**MAINE TURNPIKE AUTHORITY**

**ADDENDUM NO. 2**

**CONTRACT 2018.20**

**YORK TOLL PLAZA**  
**MILE 8.8**

YORK TOLL PLAZA  
CONSTRUCTION STAGING PLAN 3  
PHASE 3

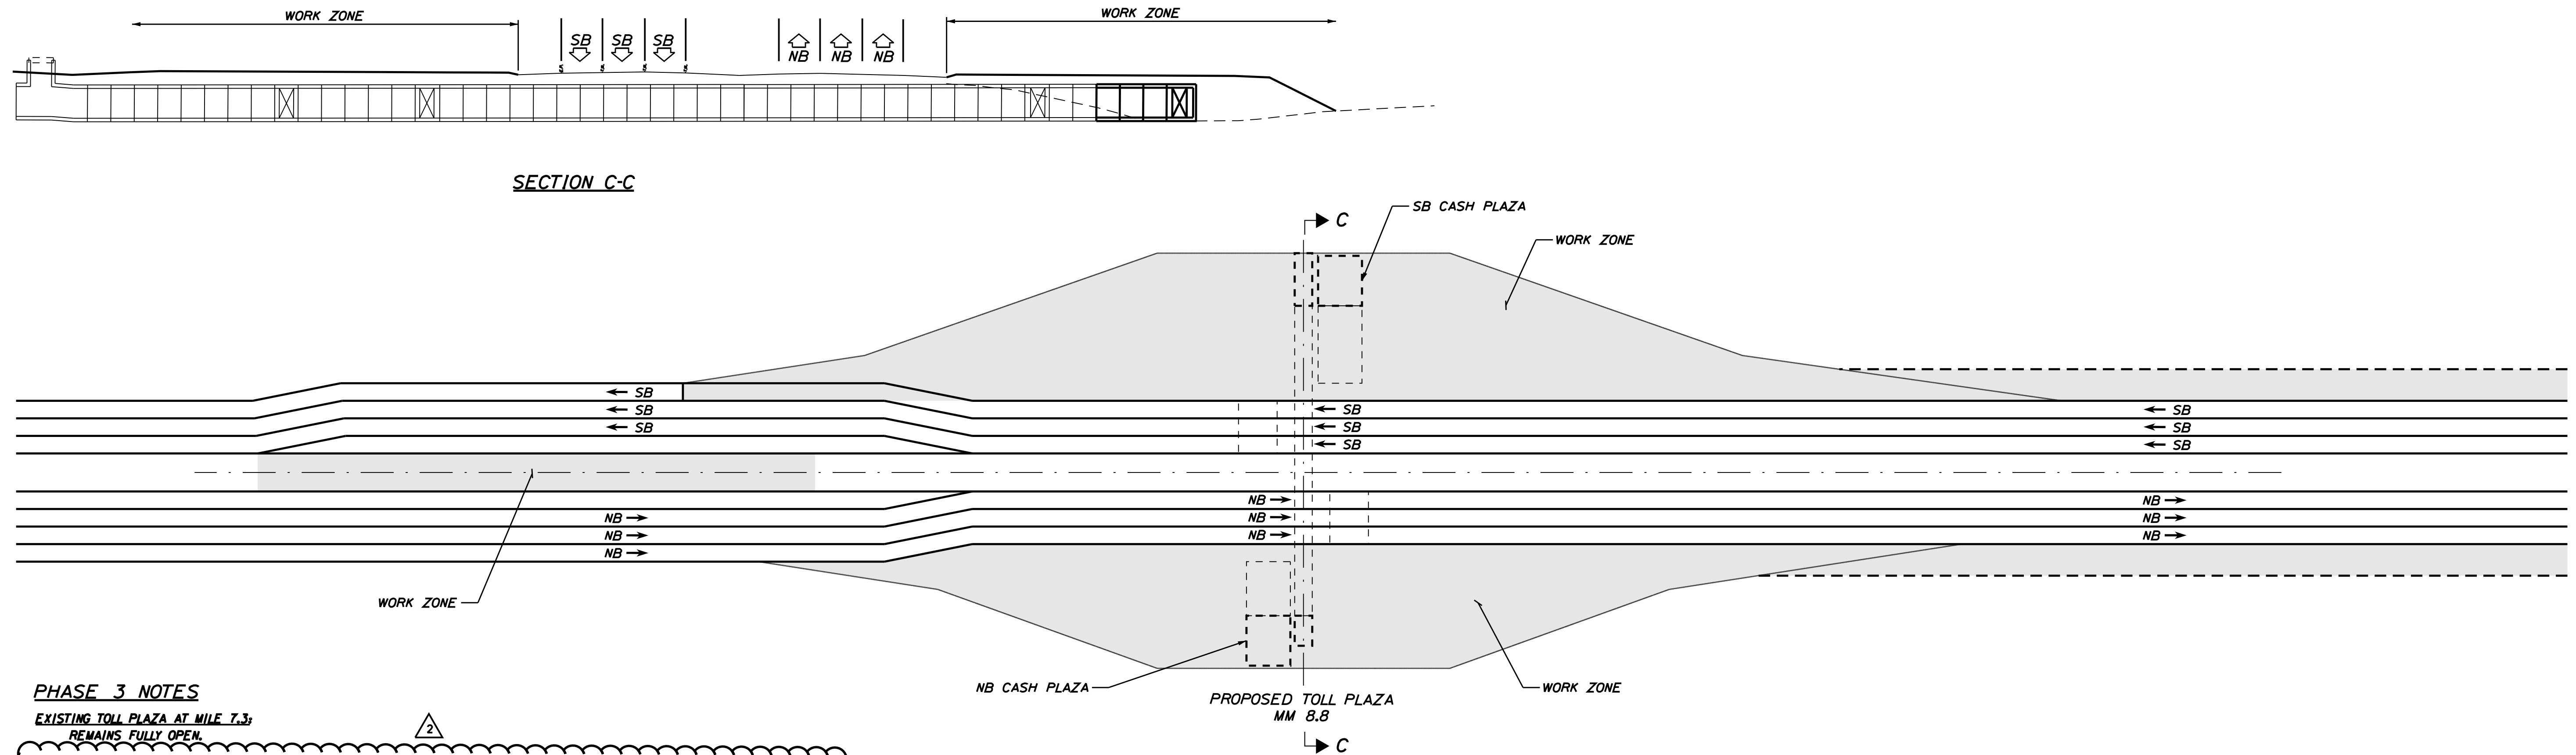
Plan Sheet 47 of 489, "Construction Staging Plan 3 - Phase 3" is deleted and replaced in its entirety with attached revised sheet 47. Note was added, "Prior to shifting traffic from phase 2 to phase 3, highway lighting mounted on barrier will be functioning".

PROPOSED LIGHTING ON CONCRETE BARRIER SHALL BE FUNCTIONING PRIOR TO SHIFTING TRAFFIC FROM PHASE 2 TO PHASE 3.  
(POLE #S: B13A, B18, B22, B23, B26, B27, B28, B29, B32, B33, B36, B38, B41)

No.	Revision	By	Date
1	Lighting note added	CSM	9/18
